STATE OF NORTH CAROLINA
DEPARTMENT OF TRANSPORTATION

July 9, 2004

SUBJECT: Permit Modification Request for TIP No. U-2527, Vance County, Western Outer Loop from SR 1128 (Ruin Creek Road) to SR 1101 (Old County Home Road) near Henderson, Federal Aid No. STP-0509(2), State Project No. 8.2390201, NCDOT Division 5, \$475 Debit WBS Element 34822.1.1.

The purpose of this letter is to request modifications to the CWA Section 404 Individual Permit issued by the USACE, the 401 Water Quality Certification issued by the NC Division of Water Quality (DWQ), and Riparian Buffer Certification issued by DWQ. Revised permit drawings are attached. A revised natural stream design plan is also attached.

SITE 3

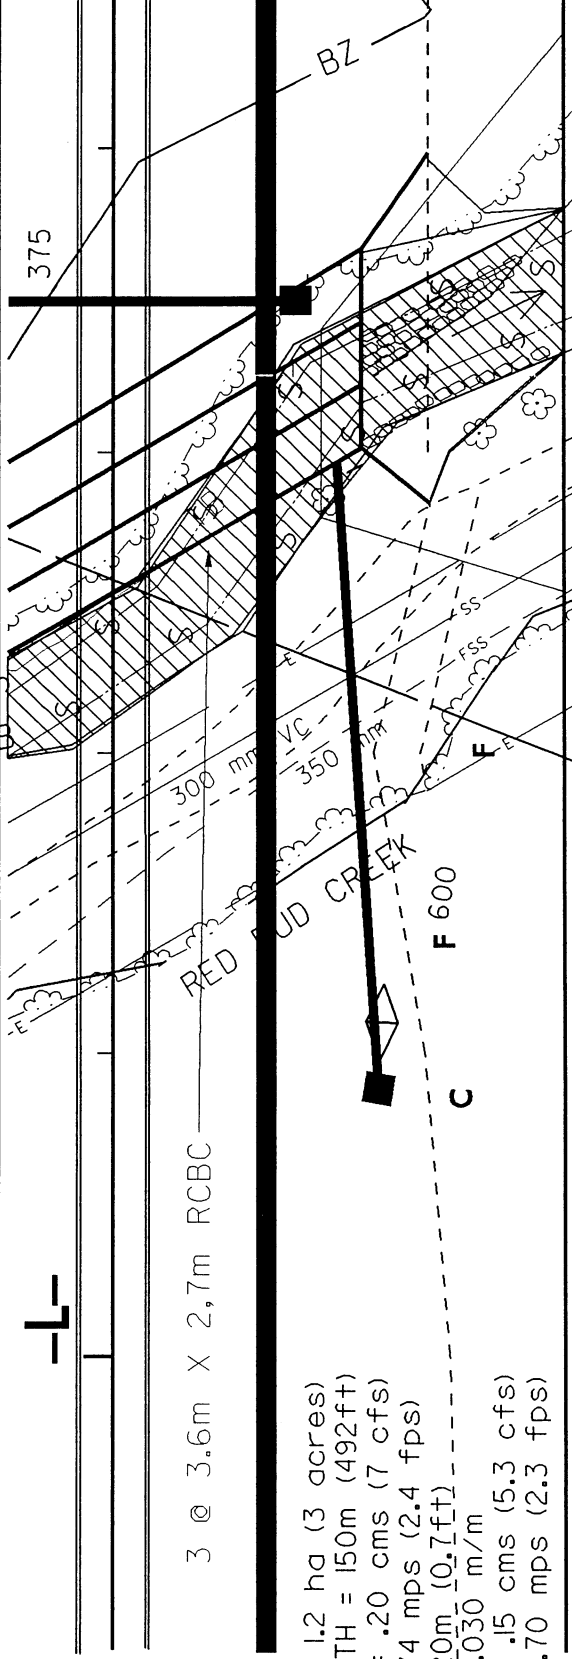
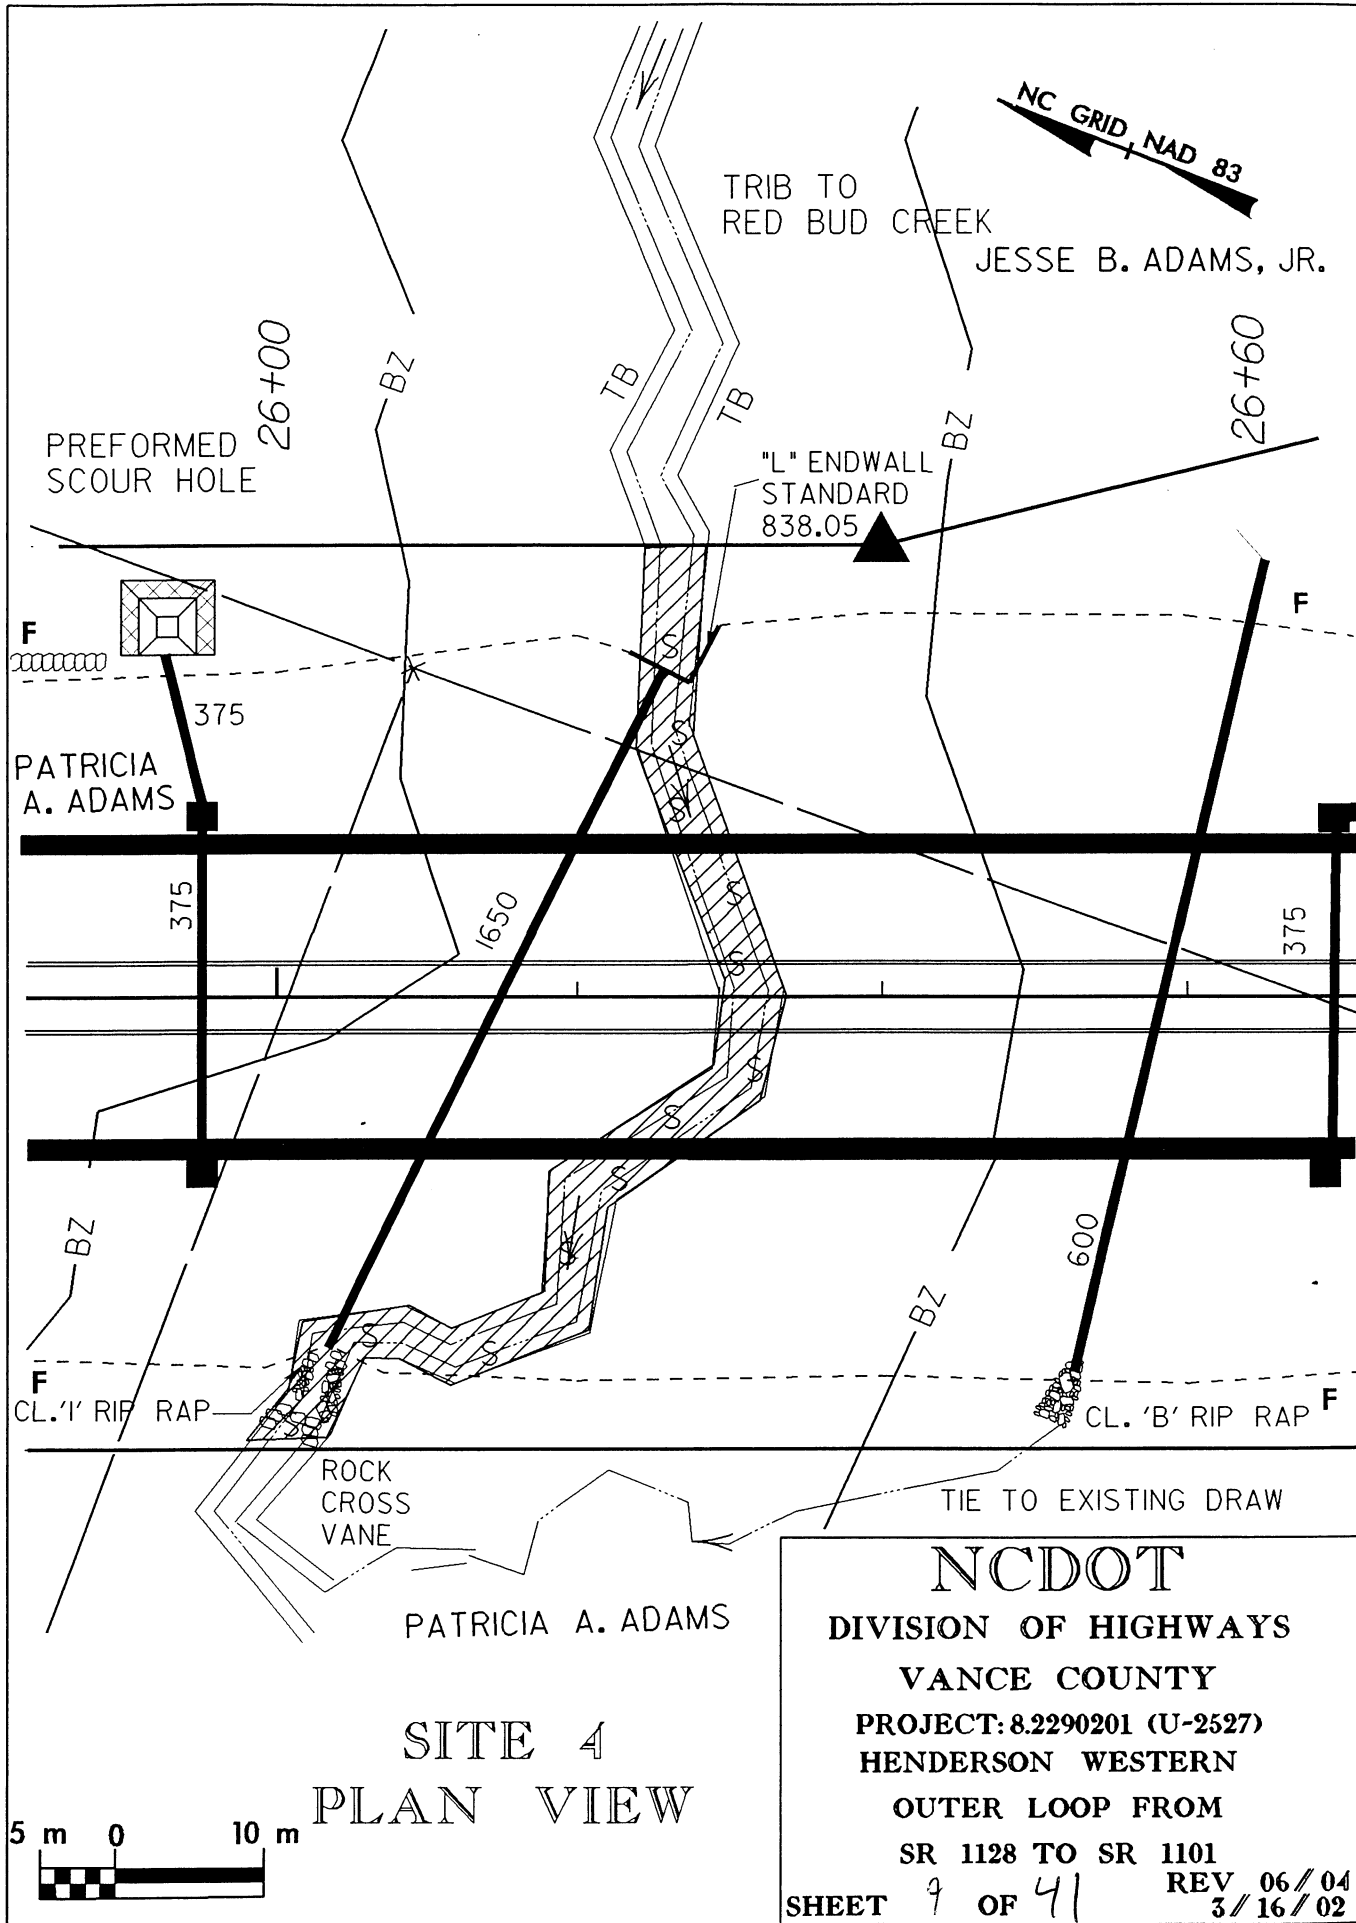
- Stream site 3, buffer site 3 (permit drawing 7, 24, and 25, plan sheet 7, Station 23+40)
 Issue: The plan sheet indicates the presence of rip rap along the northern streambank immediately upstream of the relocated channel at the inlet of the culvert. This rip rap is not depicted on the permit drawing.
 Issue: The plan sheet indicates the presence of a relocated channel, rip rap and a lateral base ditch immediately upstream of the inlet of the culvert. These impacts are not depicted on the permit drawing.
 Issue: The plan sheet indicates the presence of rip rap immediately downstream of the outlet of the culvert. The impact associated with this rip rap is not entirely depicted as a buffer impact on the permit drawing.
 Issue: There is a discrepancy in the depiction of the western fill slope between the permit drawing and the plan sheet.
 Status: The permit drawing has been modified to depict rip rap along the streambank, the additional buffer impacts and the correct fill slope. **This resulted in an increase**

of stream impact of 0.02 ac and an increase of riparian buffer impact of 0.03 ac (1306.8 square ft) in Zone 1 and 0.03 ac (1306.8 square feet) in Zone 2.

NCDOT
 DIVISION OF HIGHWAYS
 VANCE COUNTY
 PROJECT: 8.2290201 (U-2527)
 HENDERSON WESTERN
 OUTER LOOP FROM
 SR 1128 TO SR 1101
 SHEET 9 OF 41
 REV 06/04
 3/16/02

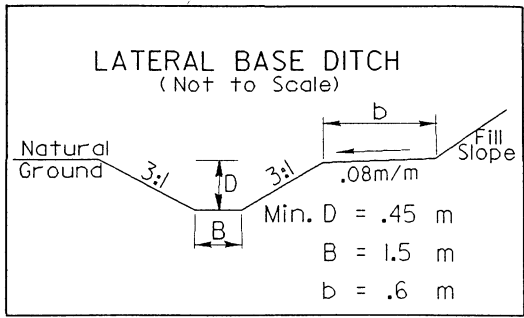
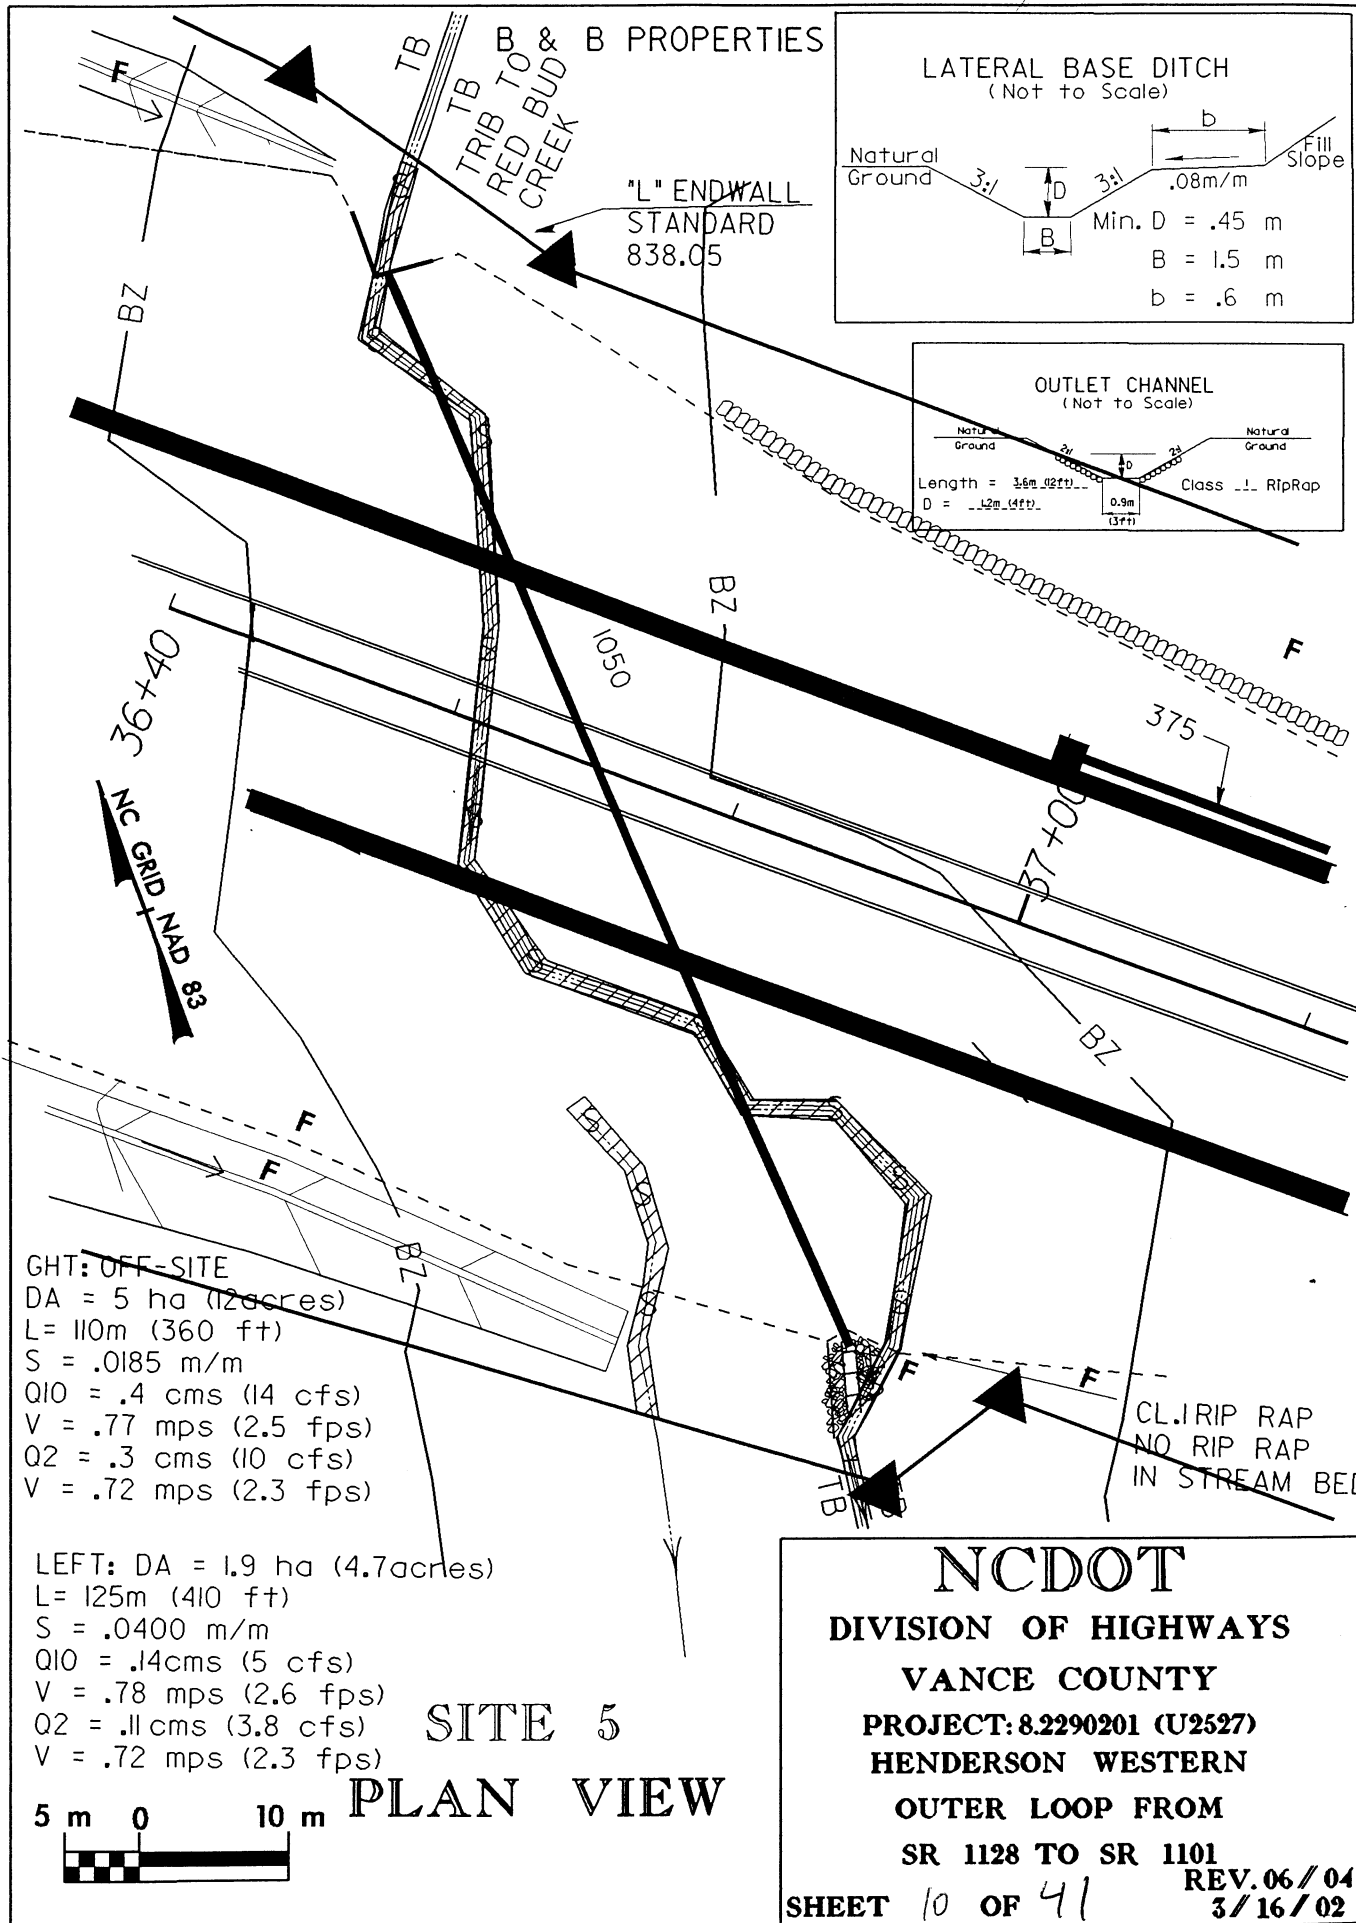
- Stream site 4, buffer site 5 (permit drawing 9 and 27, plan sheet 8, Station 26+00 to 26+30)

Issue: The plan sheet indicates that the cross pipe located at Station 26+58 is a 600mm structure. The permit drawing indicates that this cross pipe is a 450mm structure.

Issue: The plan sheet indicates the presence of a cross vane downstream of the outlet of the structure. The impact associated with the cross vane is not depicted as a buffer impact on the permit drawing.

Status: The permit drawing has been modified to depict the correct size of the structure and additional buffer impact. **This resulted in no change to stream or riparian buffer impacts.**

NCDOT
DIVISION OF HIGHWAYS
VANCE COUNTY
PROJECT: 8.2290201 (U2527)
HENDERSON WESTERN
OUTER LOOP FROM
SR 1128 TO SR 1101
SHEET 10 OF 41
REV. 06 / 04
3 / 16 / 02

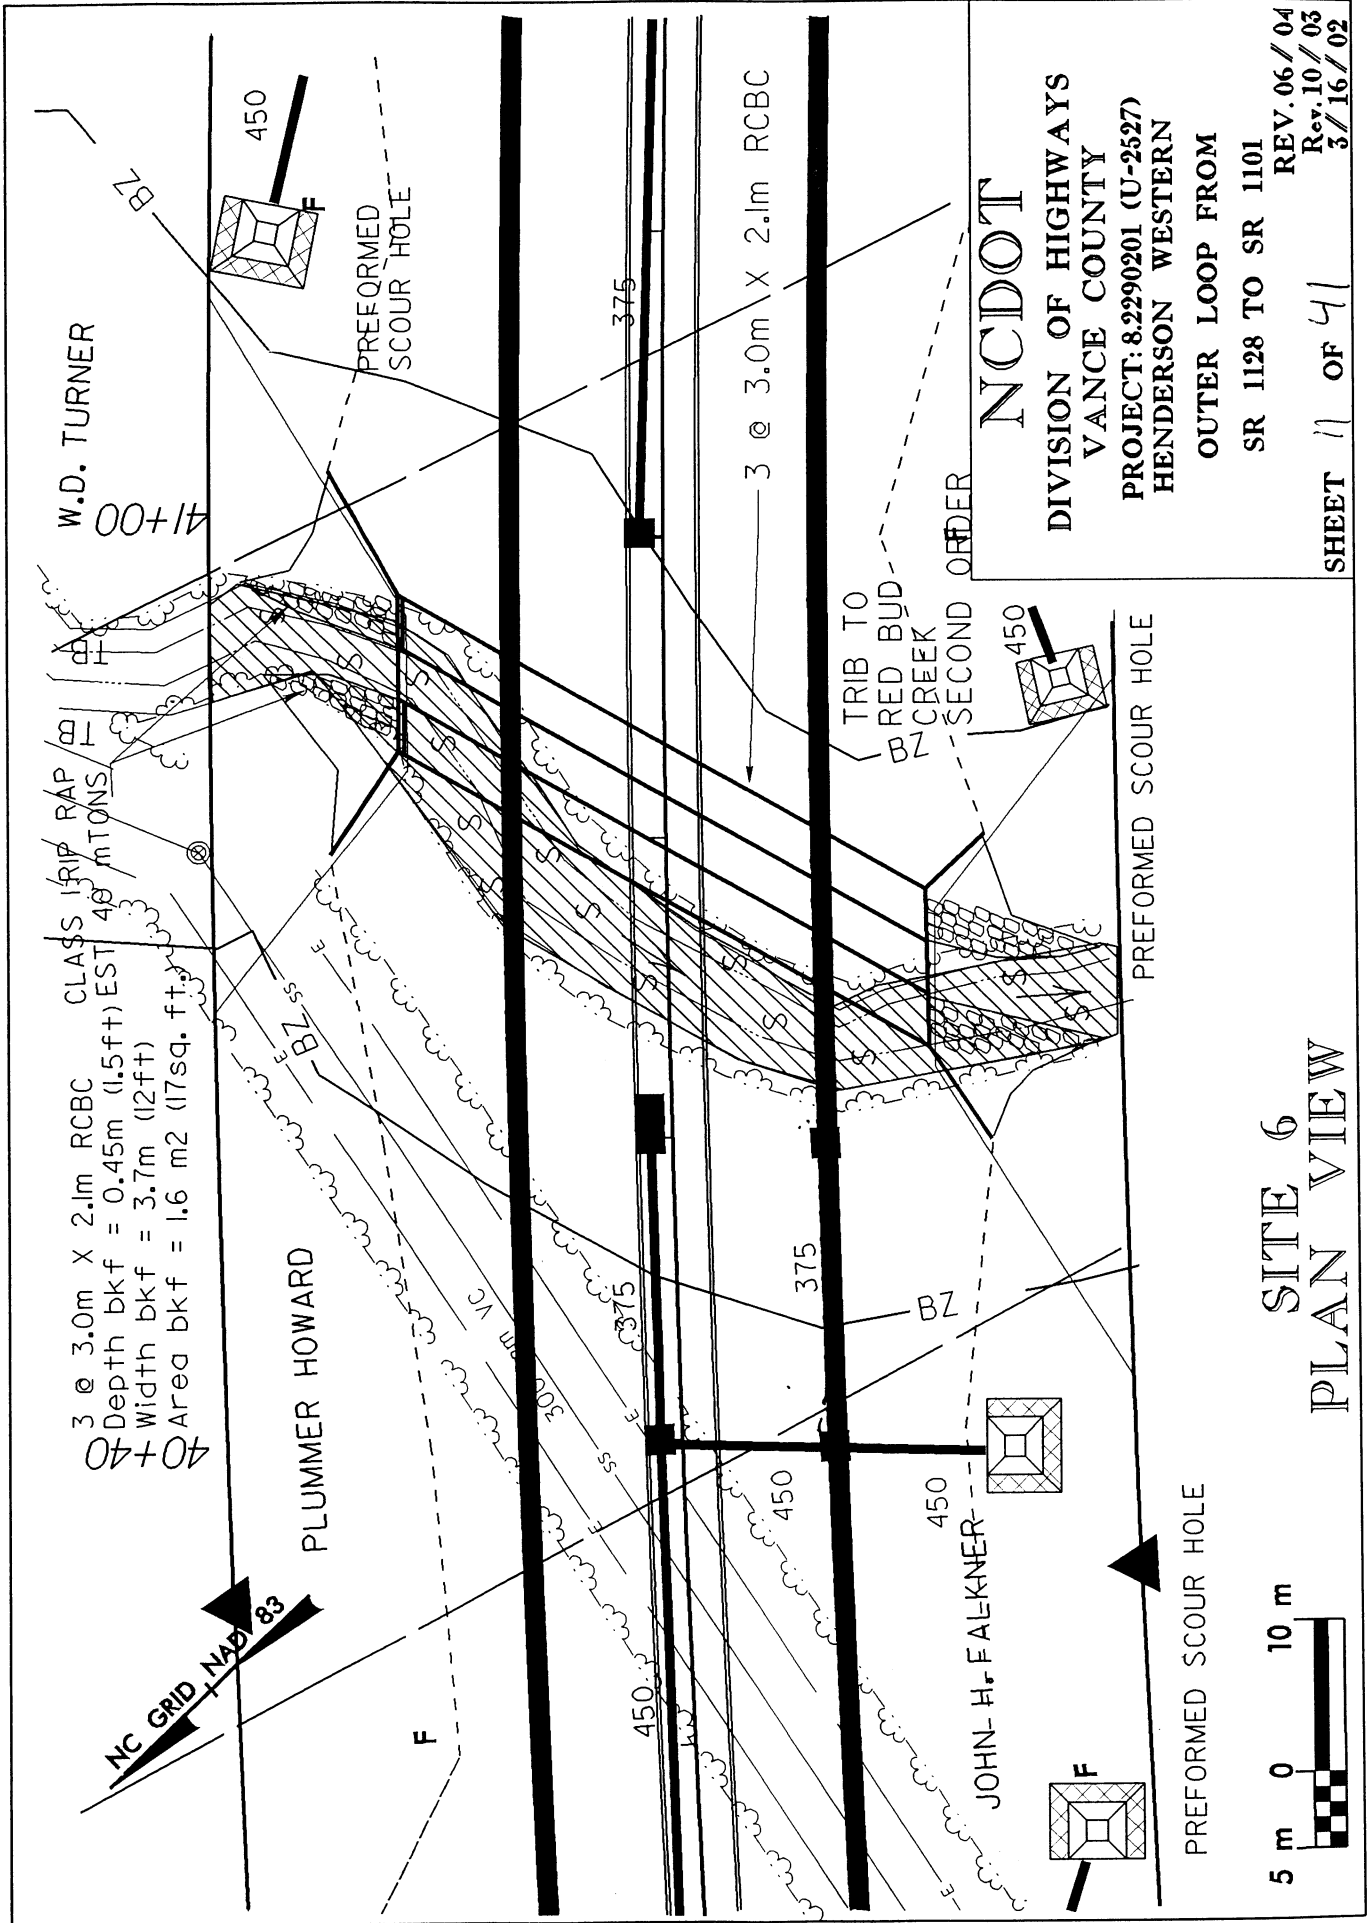
- Stream site 5, buffer site 7 (permit drawing 10 and 29, plan sheet 11, Station 36+72)

Issue: There is a discrepancy in the depiction of the southern fill slope between the permit drawing and the plan sheet.

Issue: The plan sheet depicts the installation of Class I rip rap along the streambank at the outlet of the cross pipe. The permit drawing depicts Class B rip rap at this location.

Issue: The plan sheet indicates the presence of rip rap at the outlet of the structure and lateral base ditches in the northwest and southwest quadrants. The impacts associated with the rip rap and the lateral base ditches are not entirely depicted as buffer impacts on the permit drawing.

Status: The permit drawing has been modified to depict the correct fill slope, size of rip rap and additional buffer impact. **This resulted in an increase of stream impact of 16.4 ft and an increase of riparian buffer impact of 0.02 ac (871.2 square ft) in Zone 2.**
